City of Santa Fe

# AGENDA

**REGULAR MEETING OF THE PLANNING COMMISSION FEBRUARY 04, 2021 AT 6:00 PM ATTEND VIRTUALLY**

1. **Case #2020-2998. 4193 A and B Fairly Rd & 6450 Camino Rojo Final Subdivision.** JenkinsGavin, Inc., Agent, for Homewise, Inc., Owner, requests approval of a Final subdivision plat for fifty-six single family lots. The properties are approximately 10.05 acres and are zoned R-5 (Residential- five dwelling units per acre). (Dan Esquibel, Case Manager, daesquibel@santafenm.gov, 955-6587)

# Figure 3. 3rd Left Turn Lane Added. Galisteo not relocated

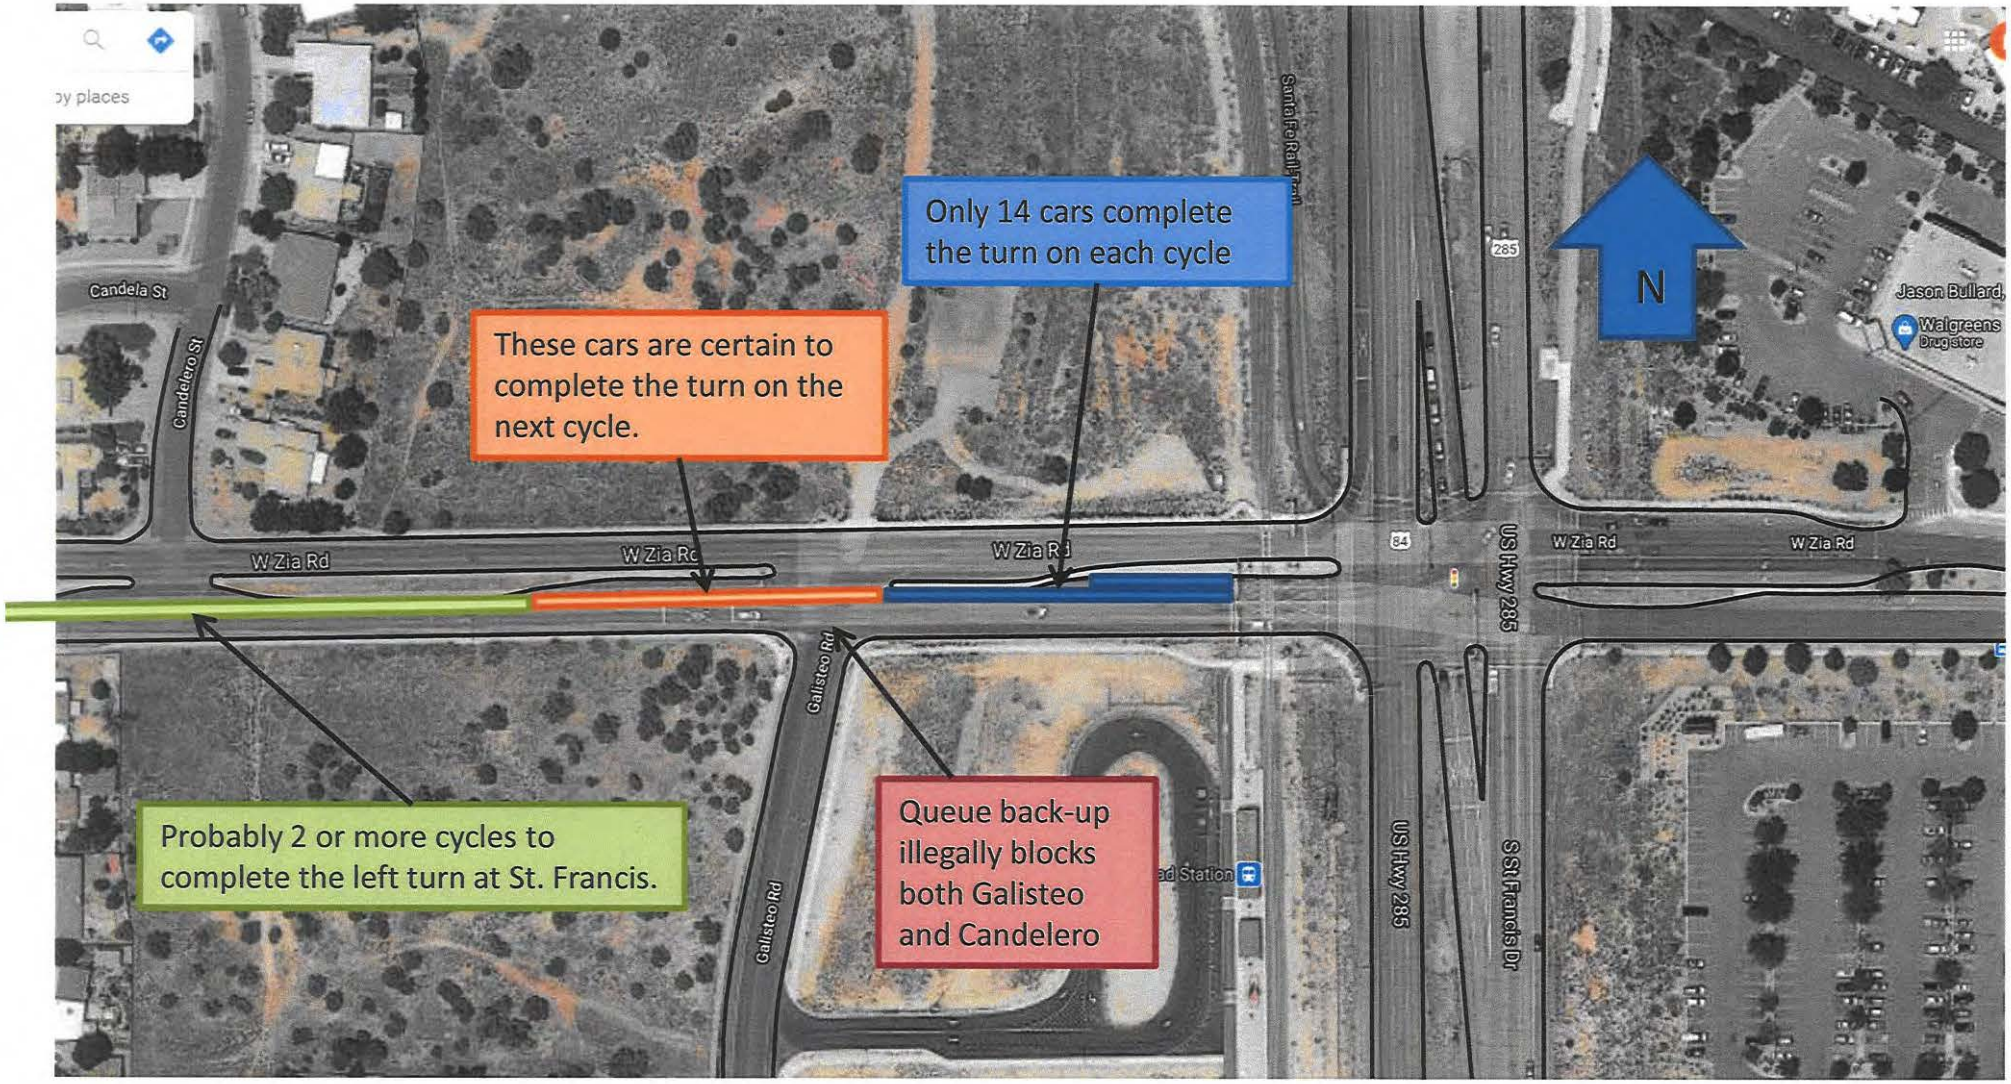
**Proposed 3-Lane Left Turn from E-bound Zia onto N-bound St. Francis.** Simply converting one of the **Zia** through lanes to a 3rd Left Turn Lane has several beneficial effects, plus two easily-fixed downsides. See **Figure 3** in Appendix II.

The second (Main) benefit is that it increases the number of autos that can complete the left turn at each green light. In the figure, the cars stopped in the front (BLUE) zone will be able to complete the left turn onto **St. Francis** on the next green light. This zone has room for 24 cars, up from 14 with only 2-lanes-left. (New capacity is 24 cars per cycle assumes no changes in green signal duration.) This significantly reduces the number of cars that were NOT able to make the turn, and thereby shrinks the amount of queue storage needed accordingly. This is shown in the **Figure 3**.

# Figure 4. 3rd Left Turn Lane Added. Galisteo relocated westward.

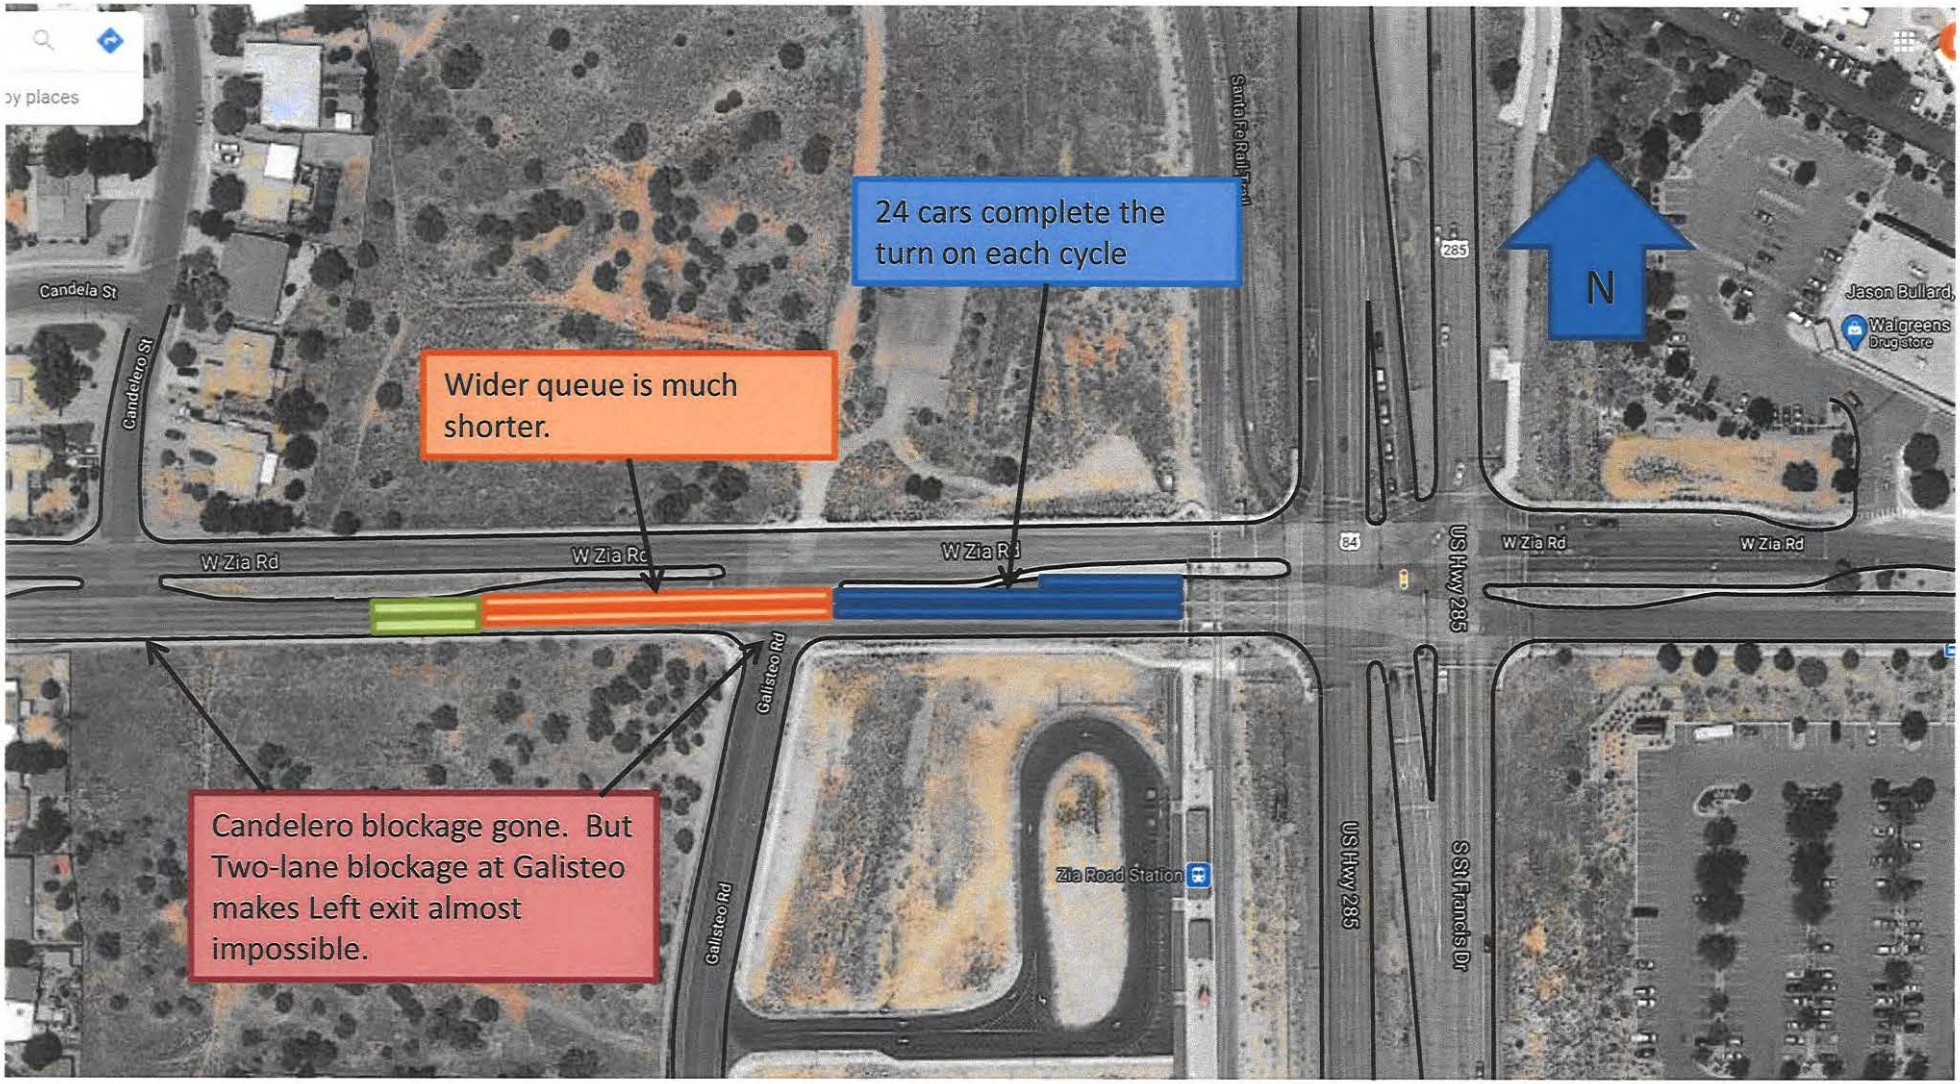
A principal side-benefit of relocating **Galisteo** westward is that it allows a MUCH longer left-turn bay at **St. Francis**. See **Figure 4** in Appendix II. This lengthening has three key advantages:

# Figure 5. Existing, successful Continuous Right Turn feature at Cerrillos and St. Michael's Drive

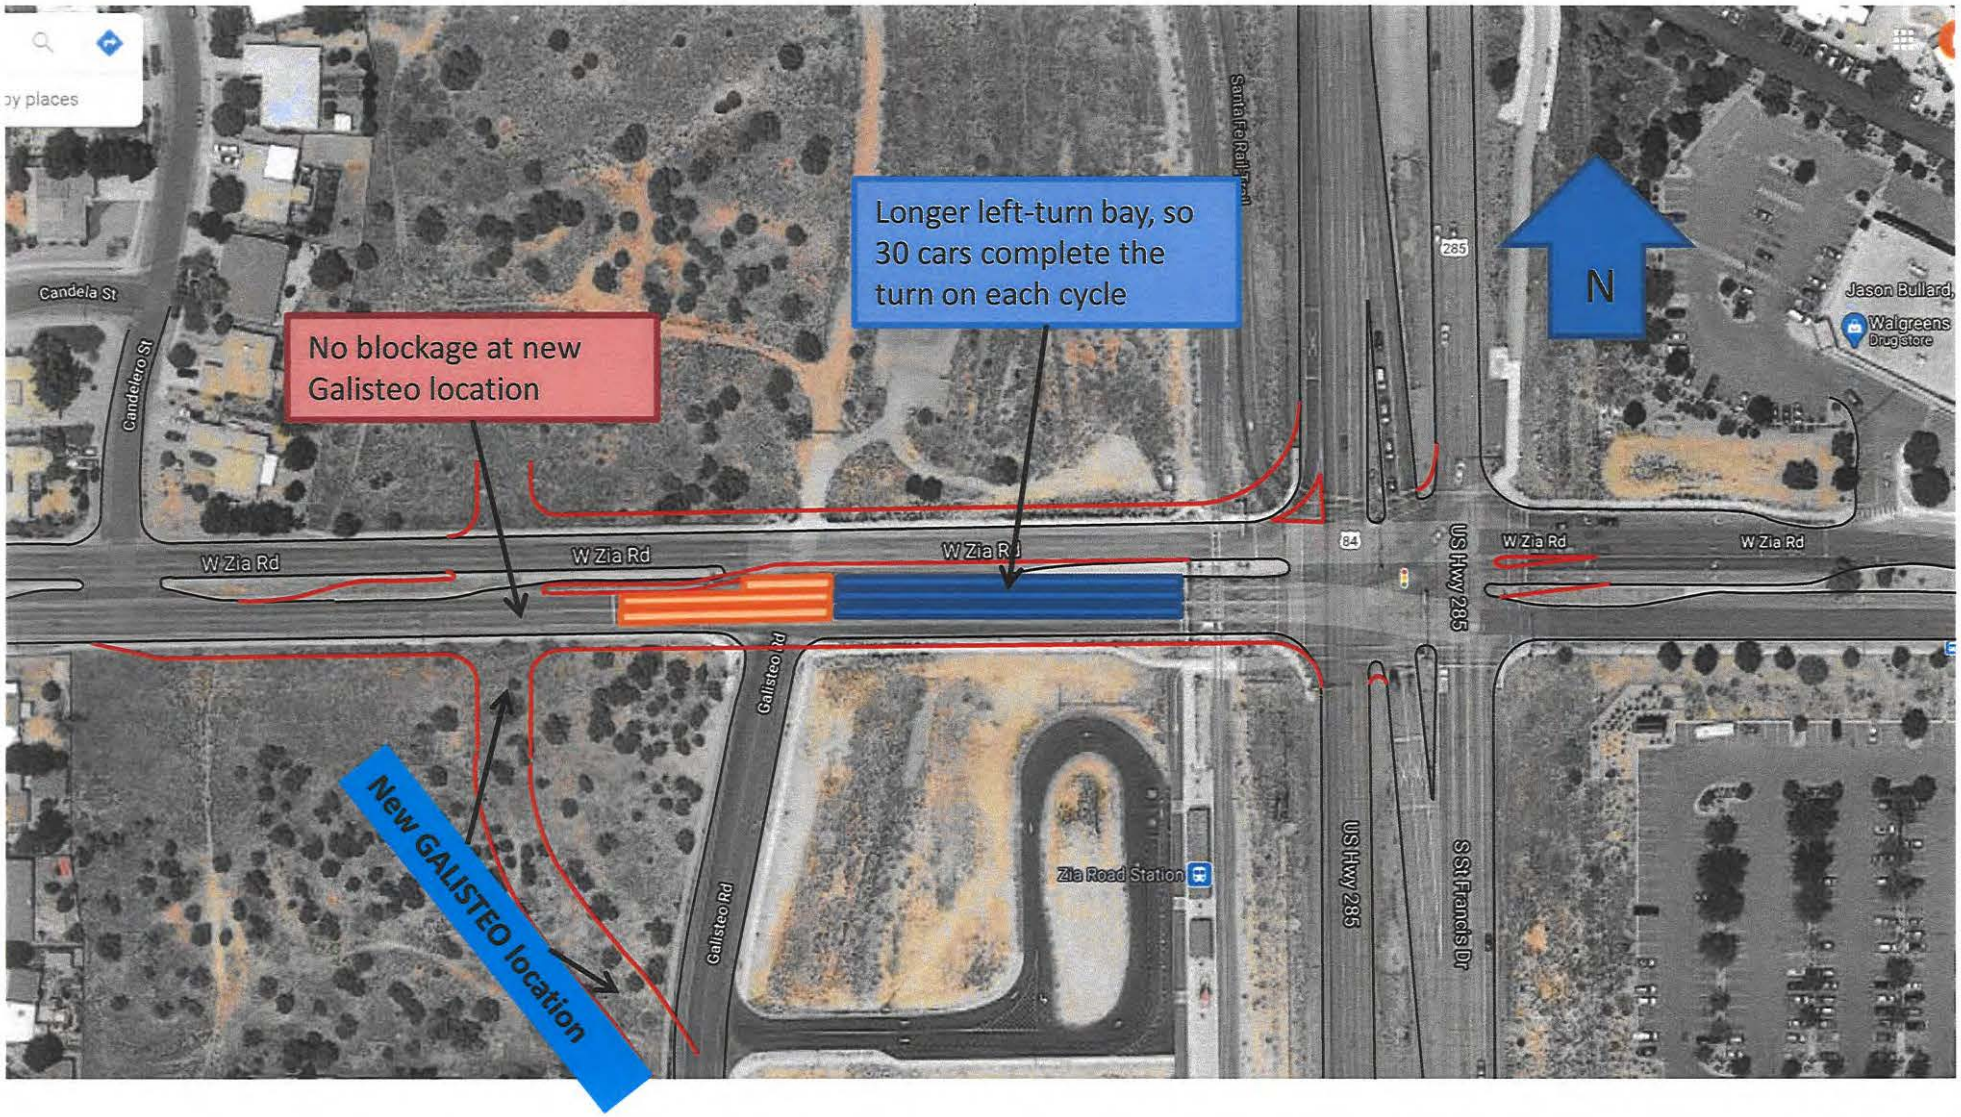
**Continuous Right Turn.** This approach is in successful use at various places around Santa Fe, and has several advantages at this intersection. One such installation is at NE-bound **Cerrillos**, for Right Turns onto SE-bound **St. Michael's Drive** (near Weck's). See photo in **Figure 5** in Appendix II.

# Figure 6.

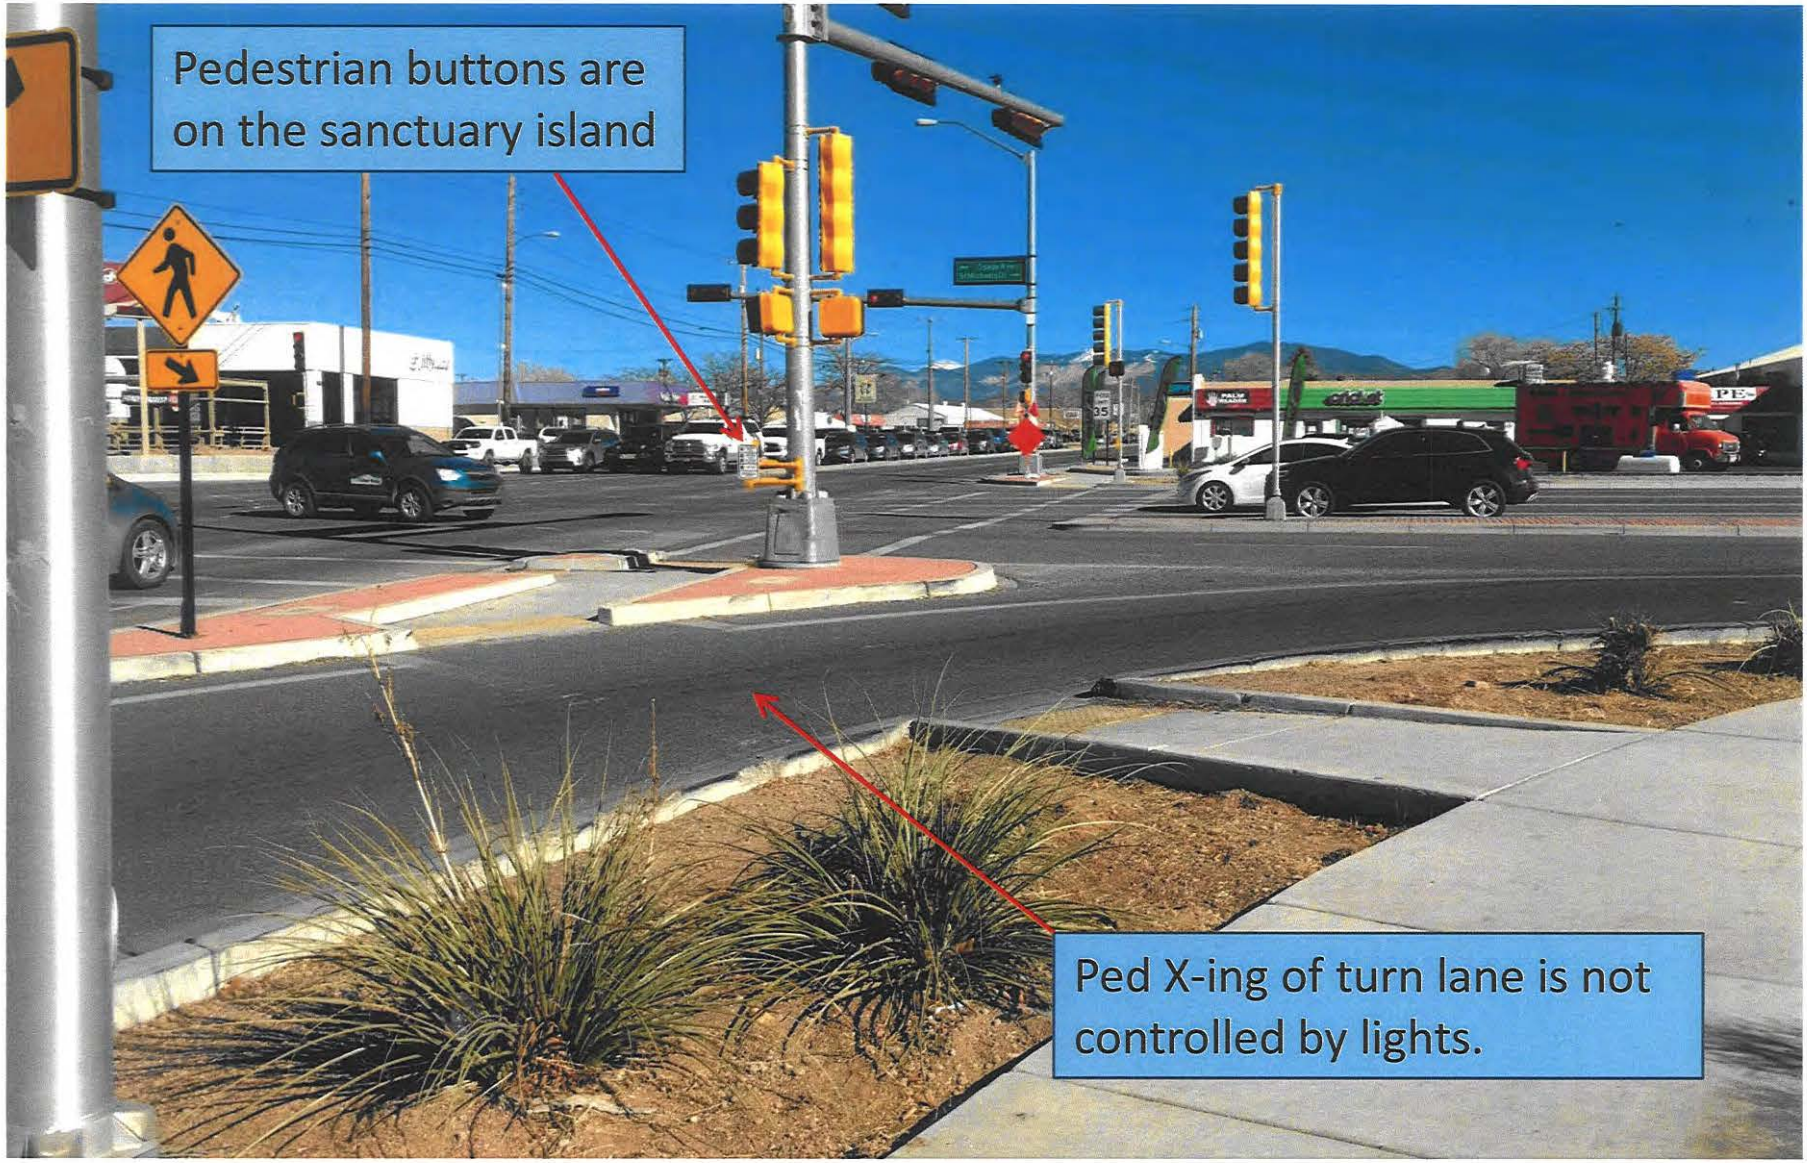
**Crossing Zia Road.** Pedestrian crossings of **Zia** have been prohibited in the vicinity of **Galisteo** for over 30 years due to already heavy traffic congestion. See **Figure 6** in Appendix II. None of the proposed improvements will remove that concern. Thus, walkers from the northern (Phase 1) development who wish to go to the RailRunner station or to any of the fine establishments south of **Zia** (Phase 2 development) must use either the RailTrail crosswalk at **St. Francis**, go to the **Candelero** intersection, or Jay-walk. We all know there will be lots of jay-walking, which is difficult to predict or analyze. We continue to be concerned about the safety of any of these crossings, legal or illegal. Also, it will be shown (below) that any increase in crossings at the RailTrail crosswalk will have very detrimental effects on S-bound **St. Francis** traffic turning onto W-bound **Zia** unless significant improvements are made to this right-turn layout and the signal light.

# Figure 7.

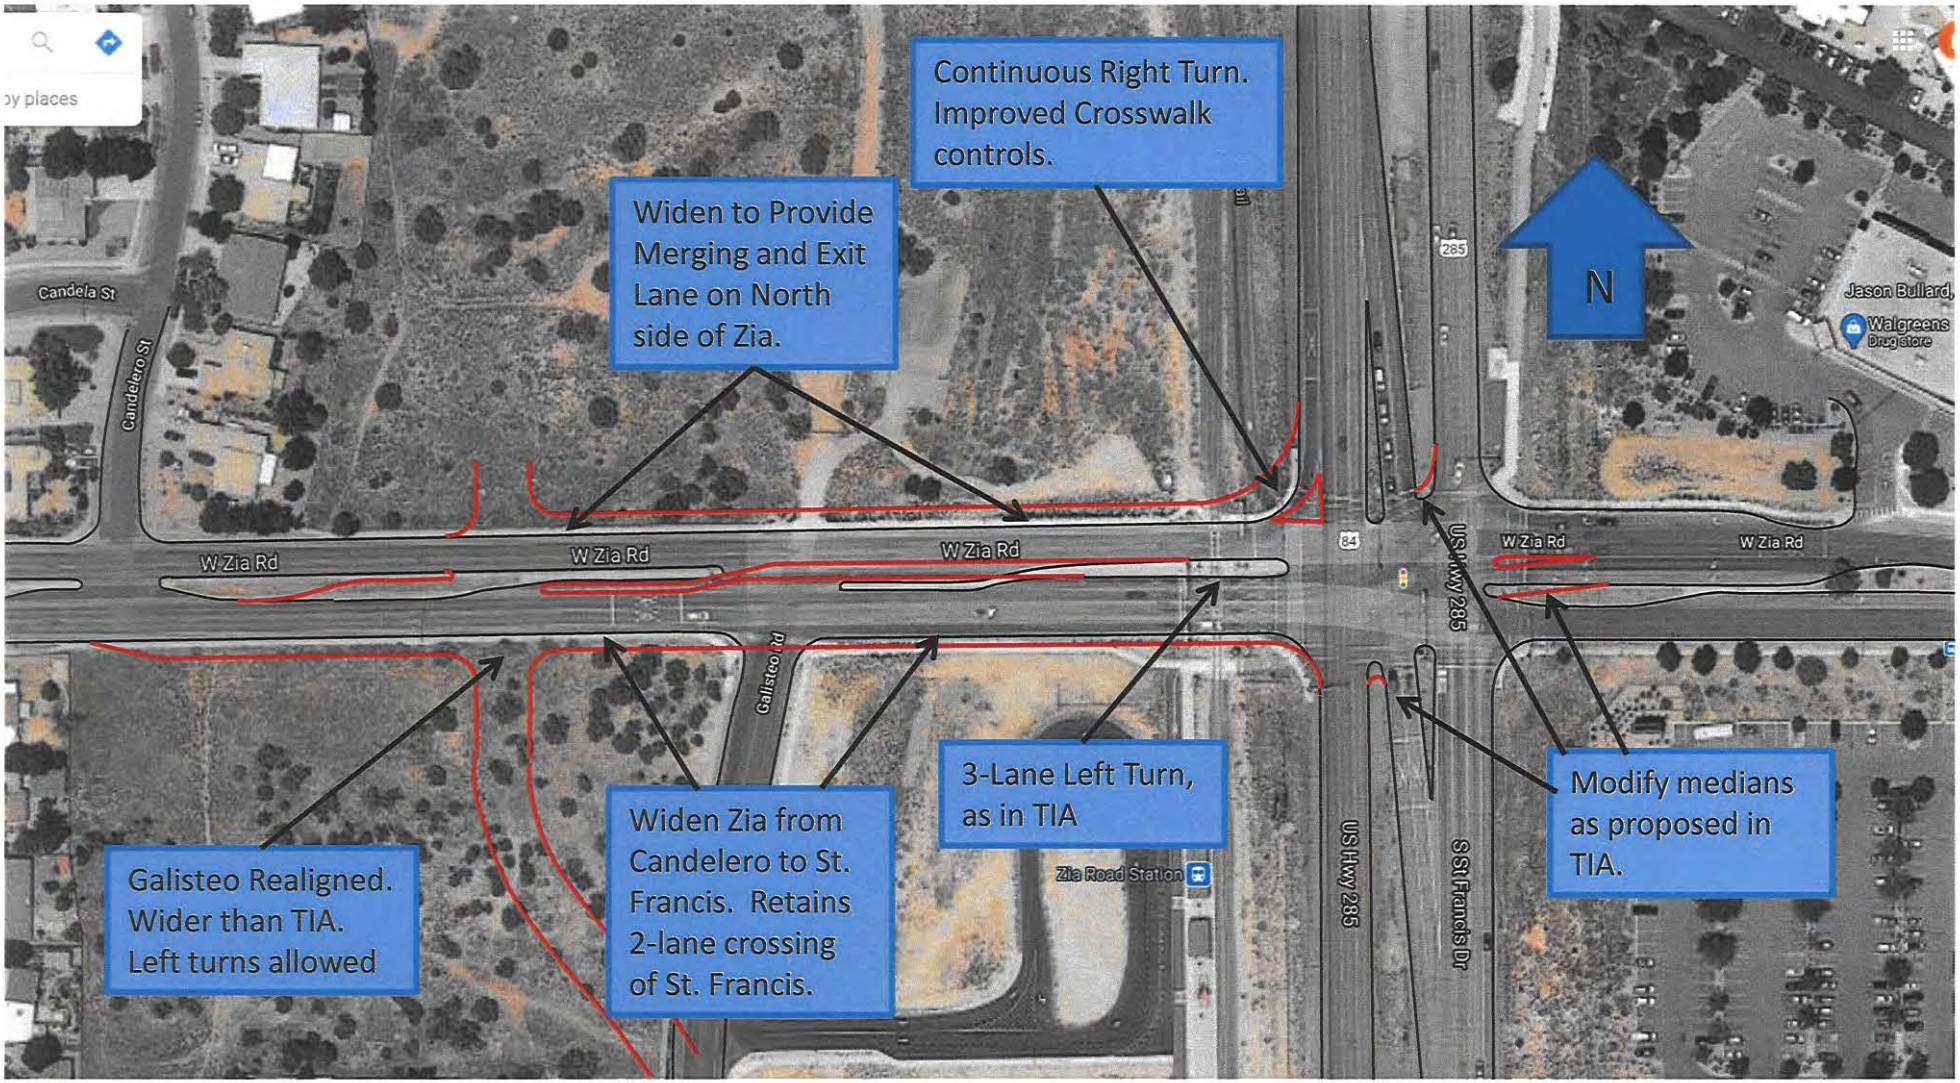
The RailTrail bicyclists will not like this solution. They are accustomed to blasting straight through, ignoring the STOP SIGN facing them at the **Zia** crossing. (See **Figure 7** in Appendix II.)
